Schematic Name: Post Review Drawings			
Page Title: Battery Box		Engineer: <Engineer>	
Project Name: <Project Name>		Designer: <Designer>	
Group Name: <System>	System: <Subsystem>	Subsystem: <Subsystem>	Last Updated By: <Updated By>
Drawing Number: <MBARI DN>	Release: <Rev>	Version: <Version>	Status: <Status>
Page Modify Date: Tuesday, May 11, 2022	Check In Date: <JCID>	Sheet	Page Count

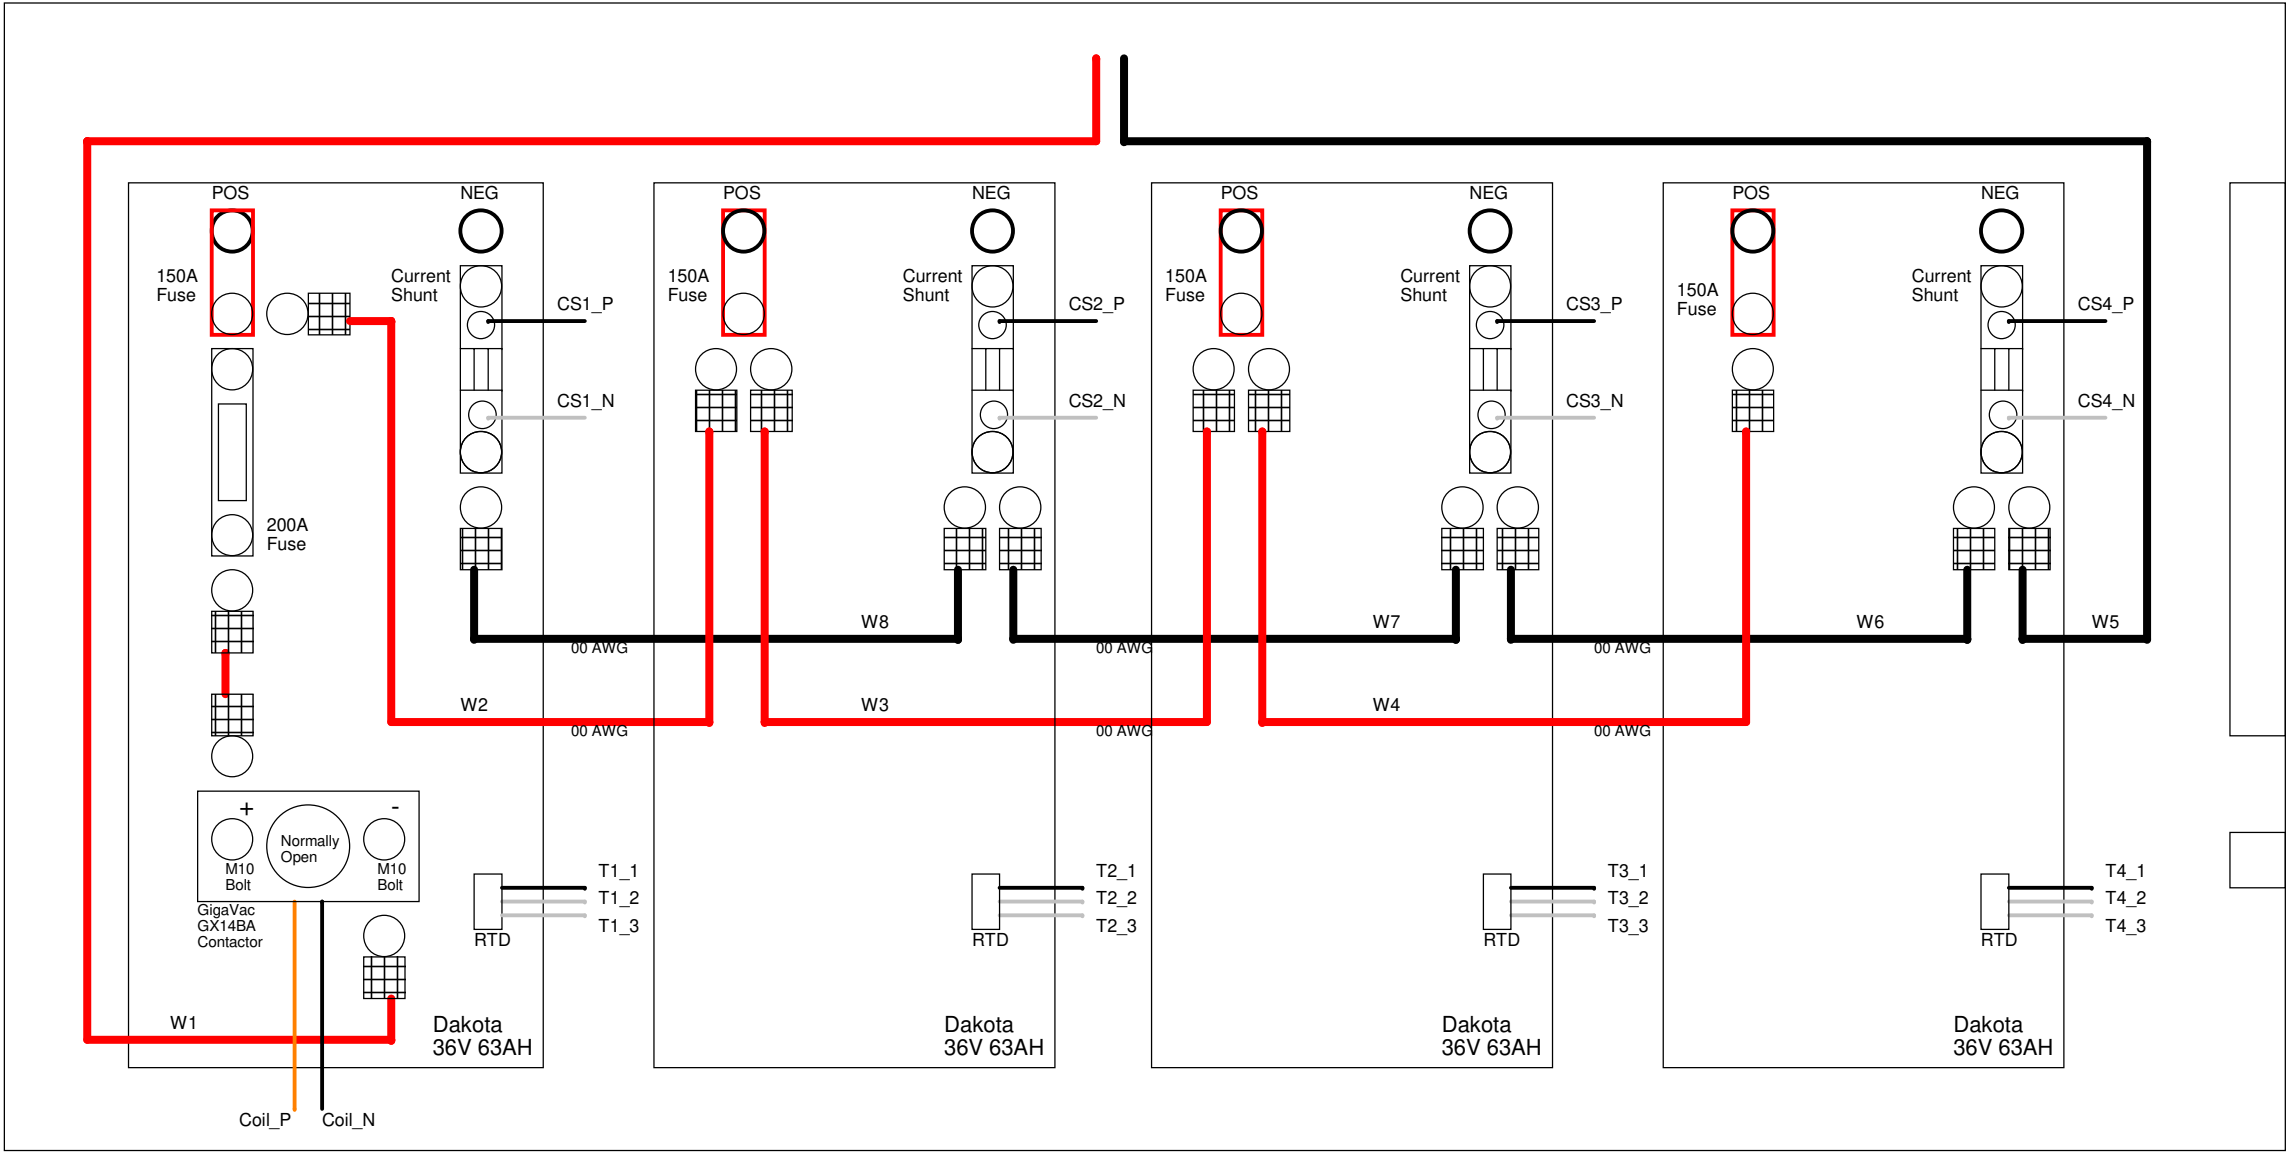
- Notes:
- Everything is enclosed in a single metal box (or two metal boxes).
 - Metal firewalls between each battery are needed.
 - Coil connections (Coil_P and Coil_N) for contactor go to a manual cutoff switch.
 - Current shunt monitor signals go to cabin front panel meter.
 - Temp sensor signals go to cabin front panel meter.
 - W2, W3, W4, W6, W7, and W8 need to be the same lengths.
 - Are the output 00AWG wires going to be attached to Moroso Panel Feedthroughs?
